MANDATORY SERVICE BULLETIN NO. MSB 62-037 REV. 2
SUPERSEDES MSB 62-037 REV. 1

Transfer to Type Certificate A00012NY and compliance with Factory Campaign FC 62-010, latest approved revision (attached).

FACTORY CAMPAIGN FC 62-010 REV. 6
SUPERSEDES FC 62-010 REV. 5

Issuance of Type Certificate A00012NY.

Figure 1. Location of supplemental data plate.

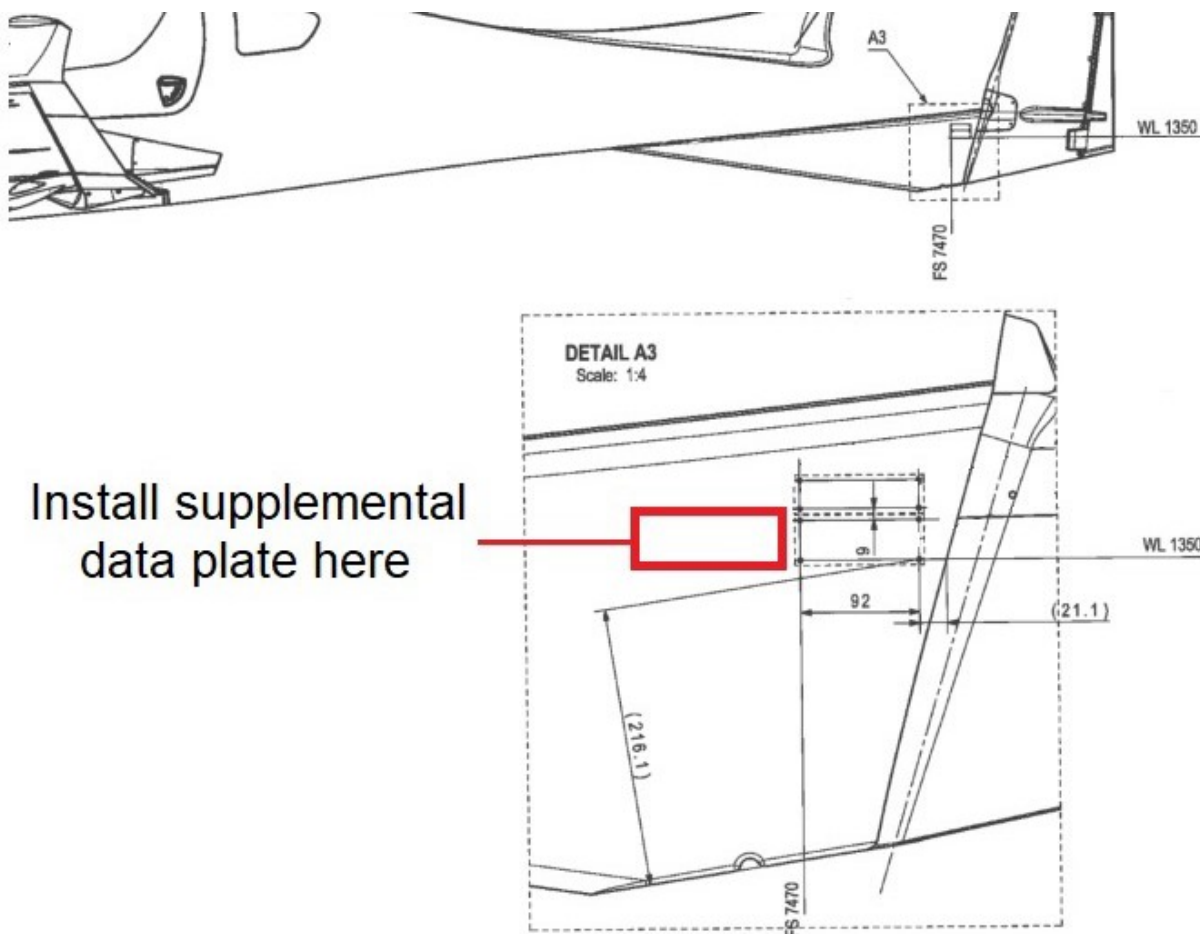
1. Install the new data plate (item 1 or item 2) adjacent to the data plate currently on the aircraft as shown in Figure 1. Use blind rivets ISO 15983-3.2x10-A2 (item 3).
 - A. Install item 1 on aircraft produced by Diamond Aircraft Industries GmbH.
 - B. Install item 2 on aircraft produced by Diamond Aircraft Industries Inc.
2. Clean debris from the inside of the vertical stabilizer.
3. Clean working areas, check for foreign objects.
4. Check all altered, replaced, repaired parts for proper function.
5. Test all systems in working areas for proper function.
6. Make all necessary entries in the airplane logs, and record VÄM 62-001 as implemented in the modification status.
